ORIGINATION FORM

Proposed Revisions to a Standard Plans Index

Index Number: 443-001

Index Title: French Drain

SHEET
1 of 3

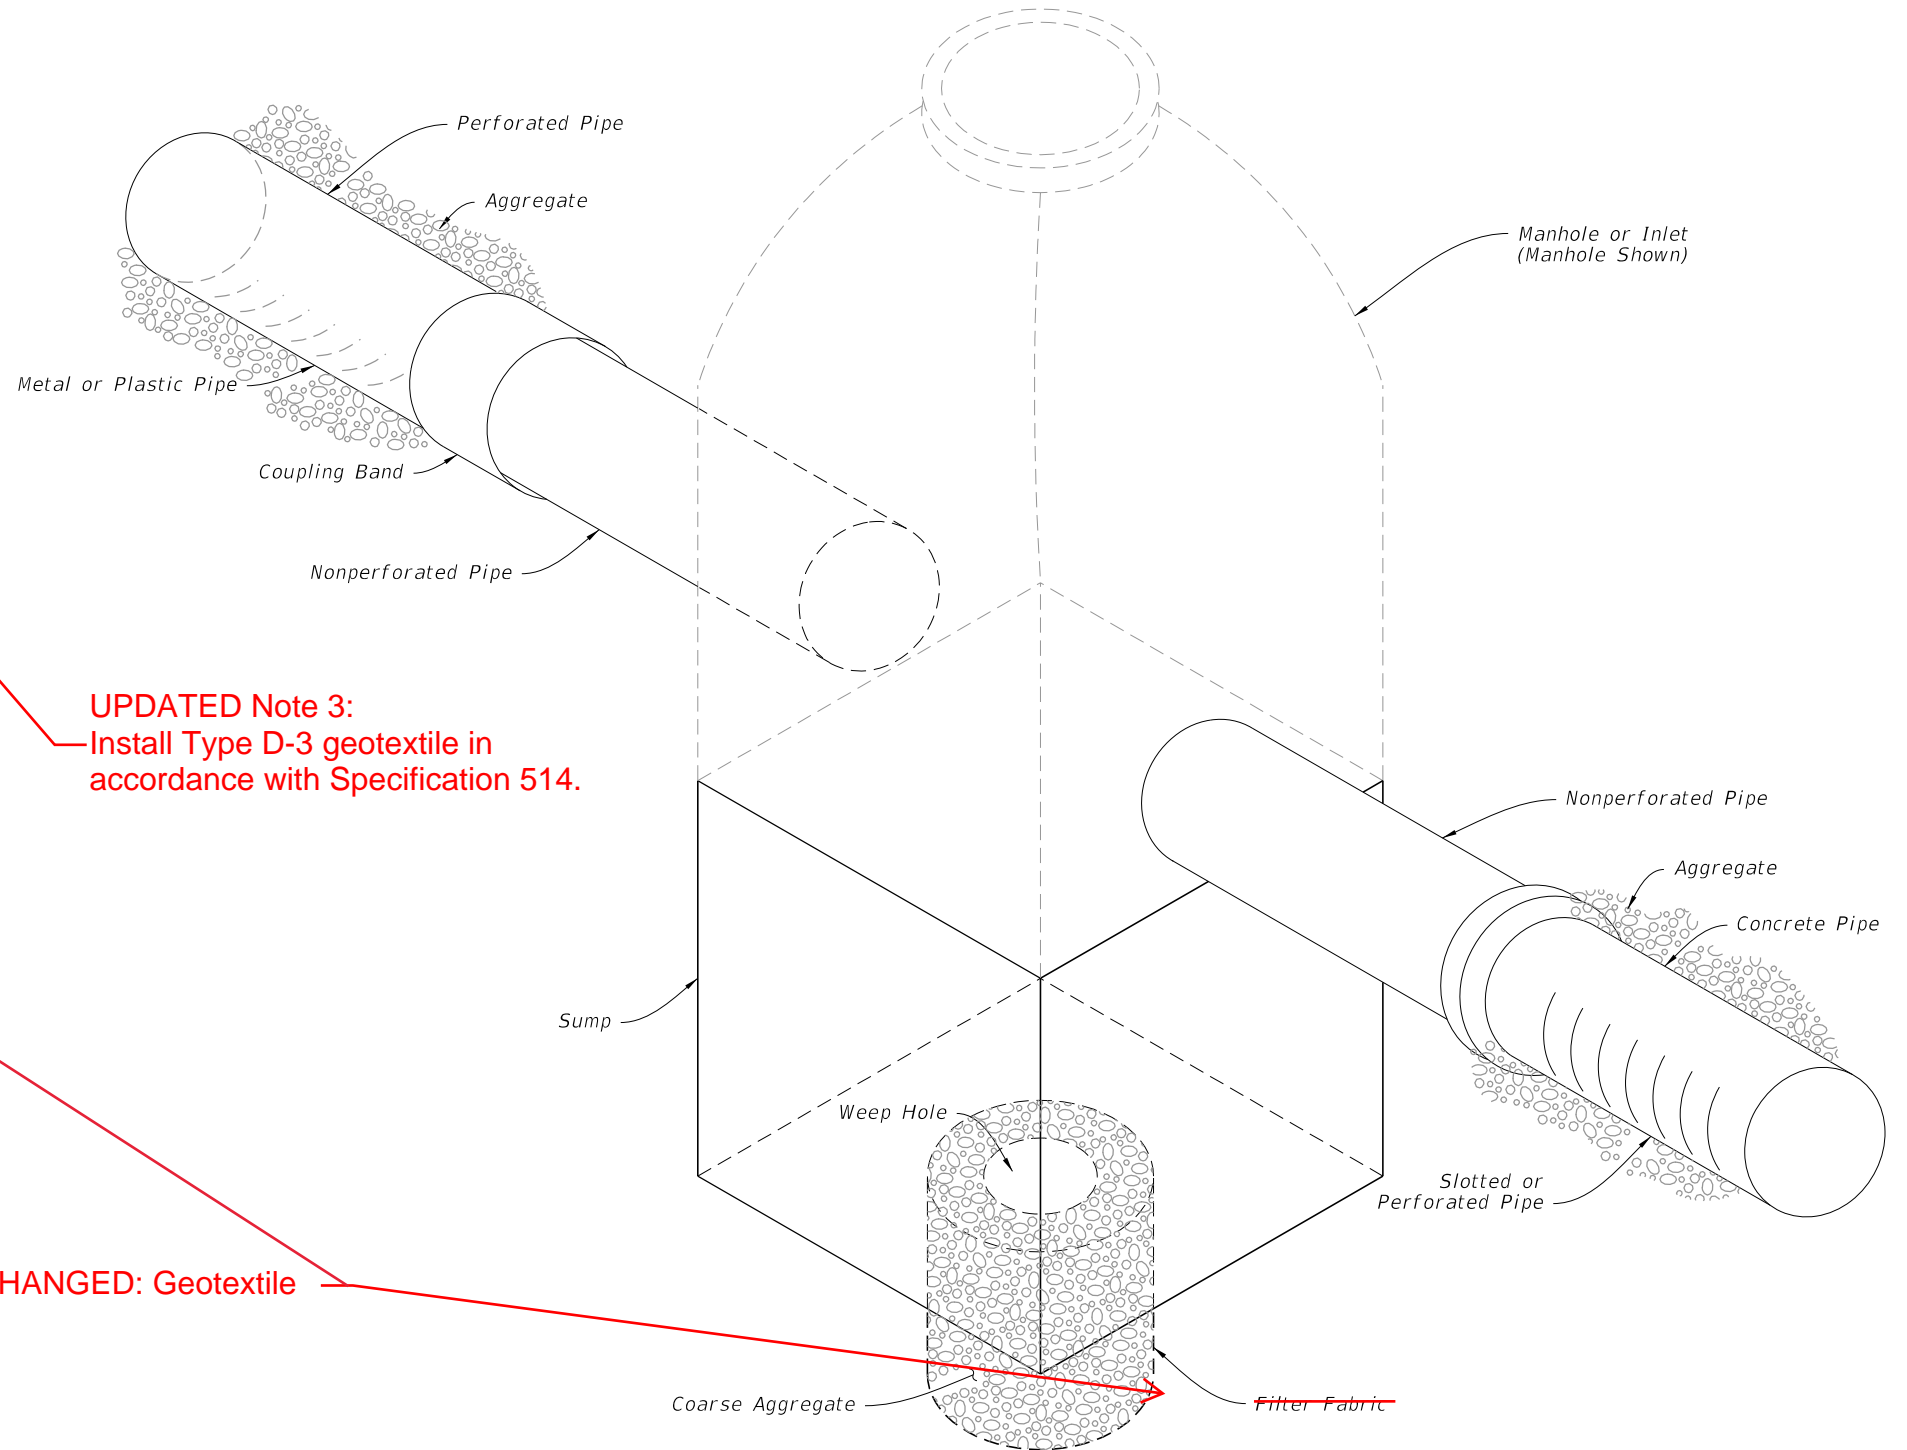
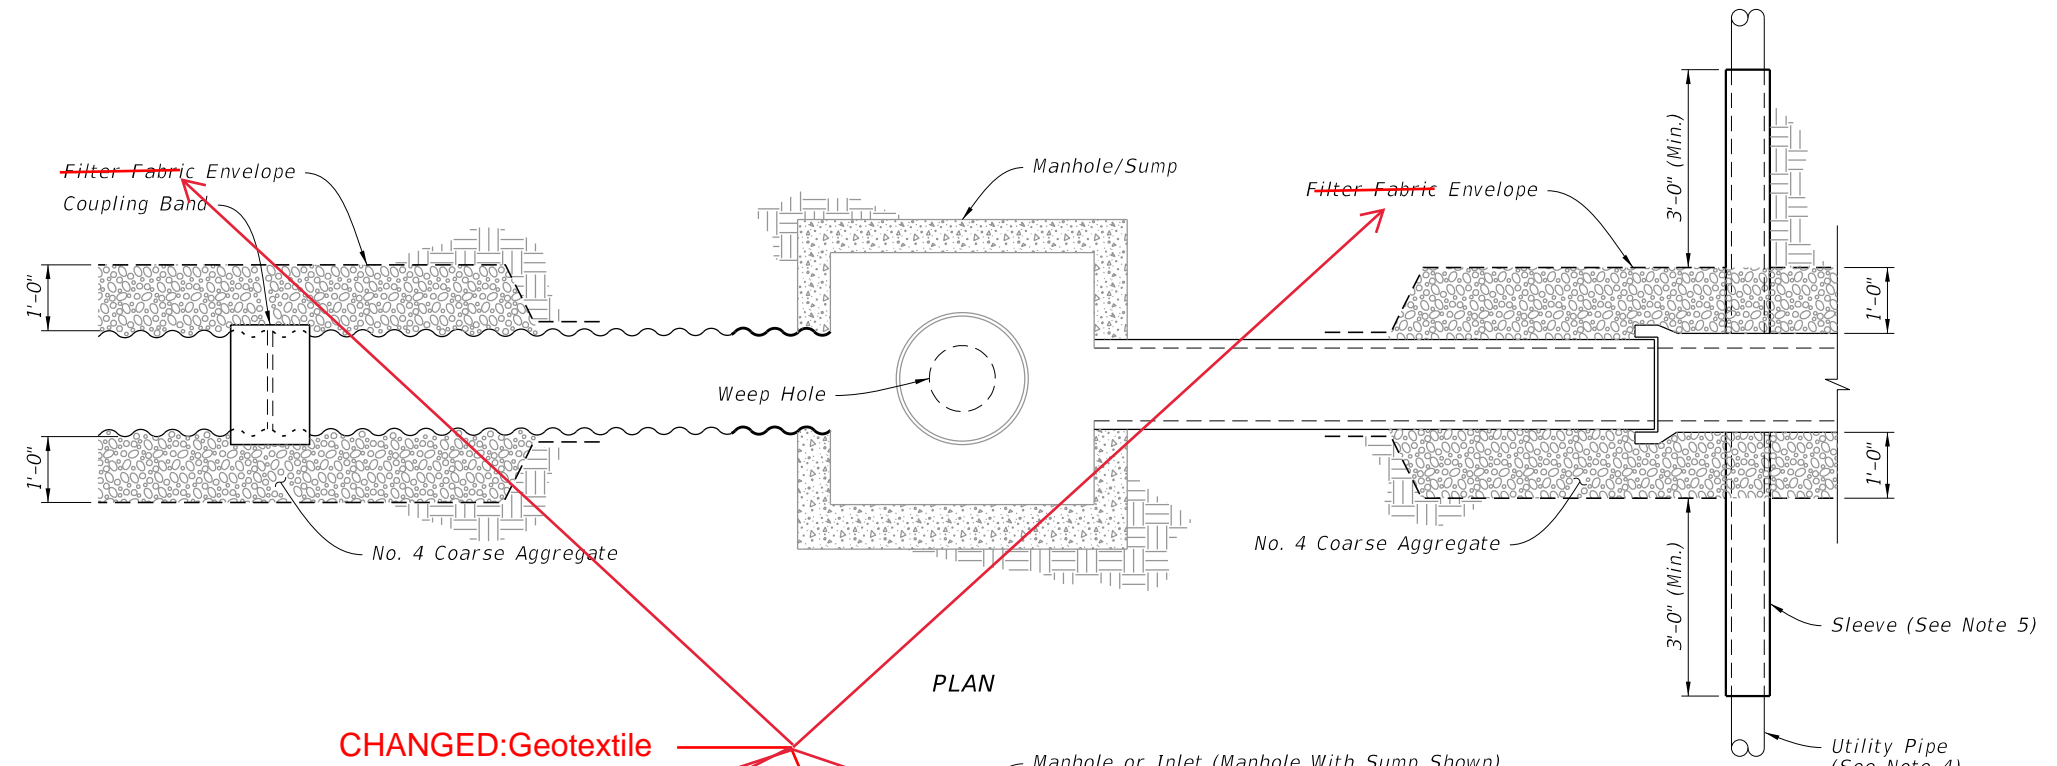
Sheet 1: Updated GENERAL NOTE 3 "Install Type D-3 geotextile in accordance with Specification 514."; Changed all references of "Filter Fabric" to "Geotextile".

UPDATED Note 3:
Install Type D-3 geotextile in accordance with Specification 514.

CHANGED: Geotextile

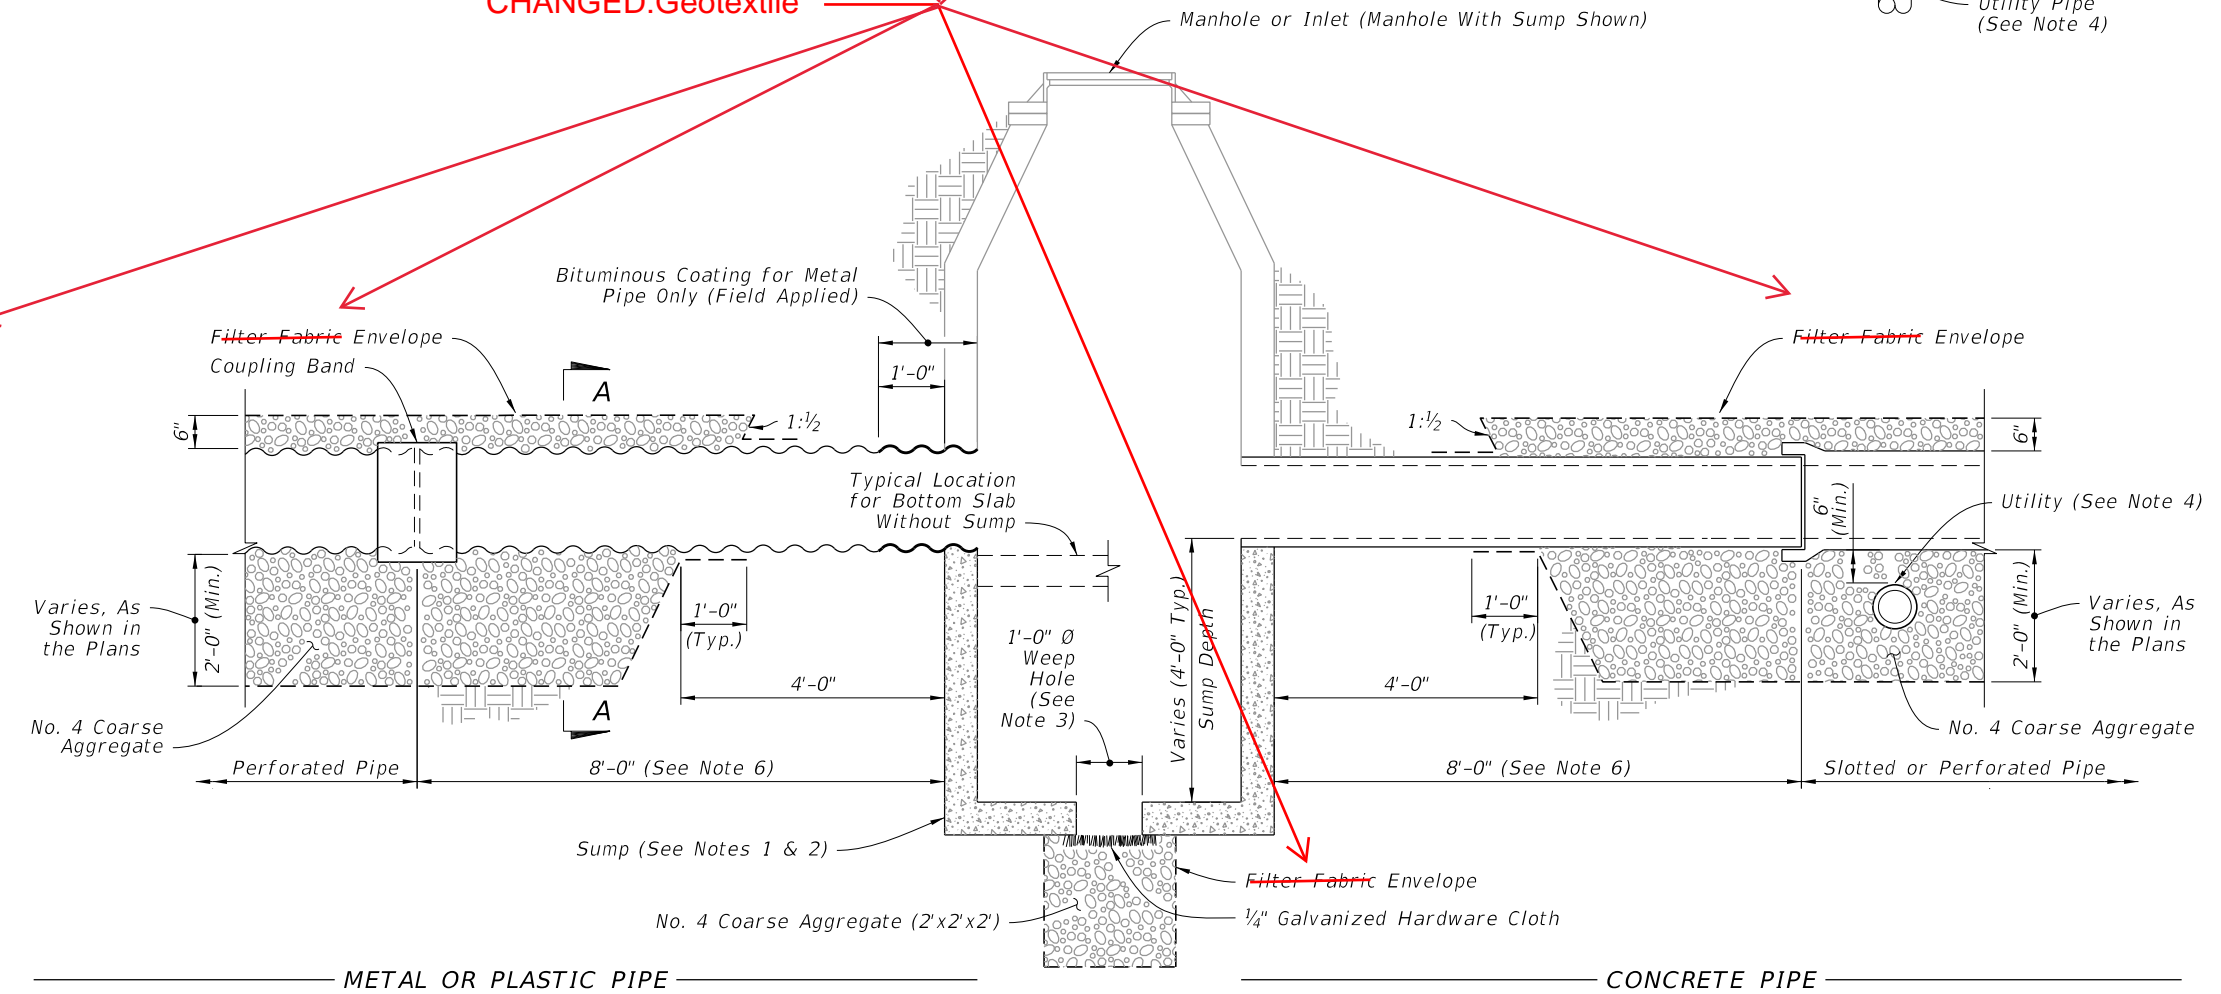
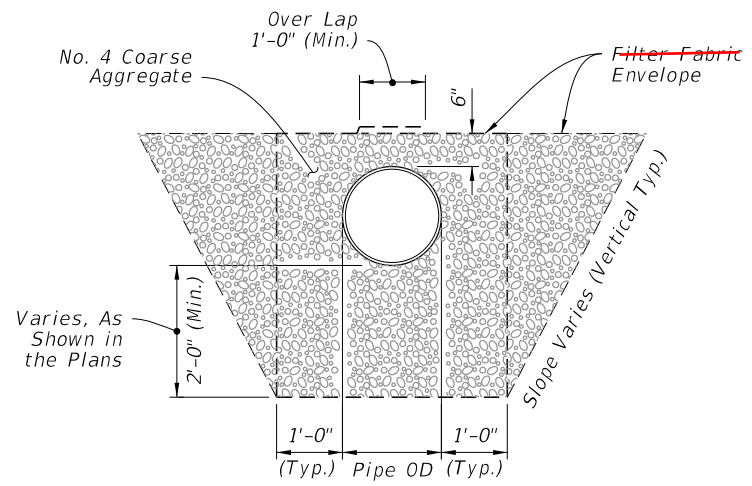
Sheet 2: Changed all references of "Filter Fabric" to "Geotextile".

CHANGED: Geotextile

TABLE OF CONTENTS:	
Sheet	Description
1	General Notes and Contents
2	French Drain System
3	Concrete Slotted Pipe Options

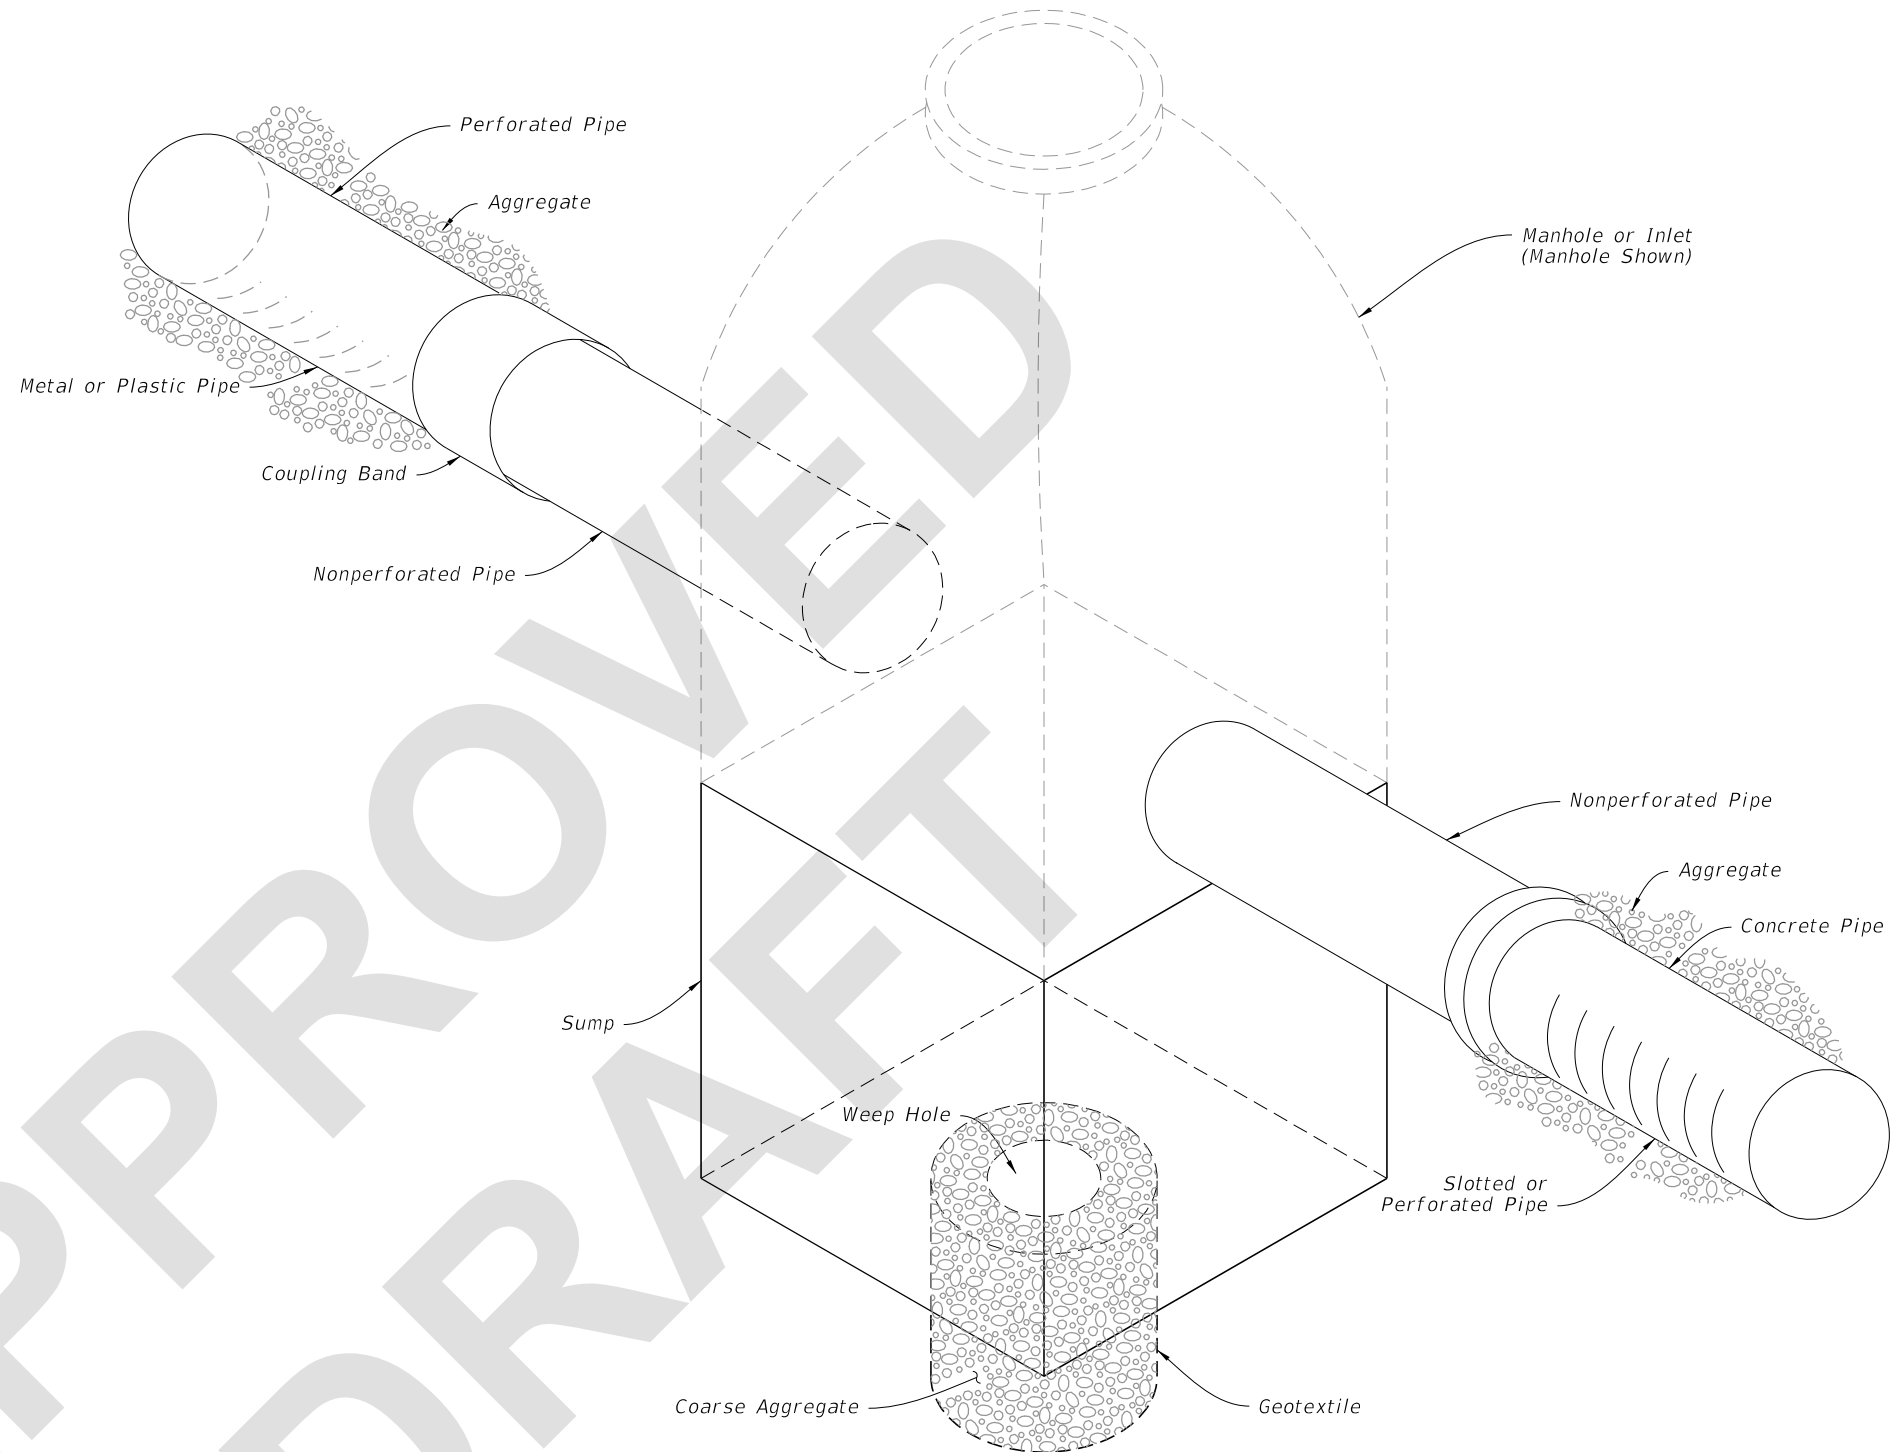
1. Place concrete pipe with the slots positioned on sides.
2. Alignment joints are standard (gaskets not required). Recorrugation of metal pipe ends not required.
3. Install Type D-3 geotextile in accordance with Specification 514. Lap all geotextile joints a minimum of one (1) foot.
4. Construct the standard cross section unless other section(s) described or detailed in the plans.
5. See Index 430-001 for supplemental details.
6. Take the necessary precautions to prevent contamination of the trench with sand, silt and foreign materials.
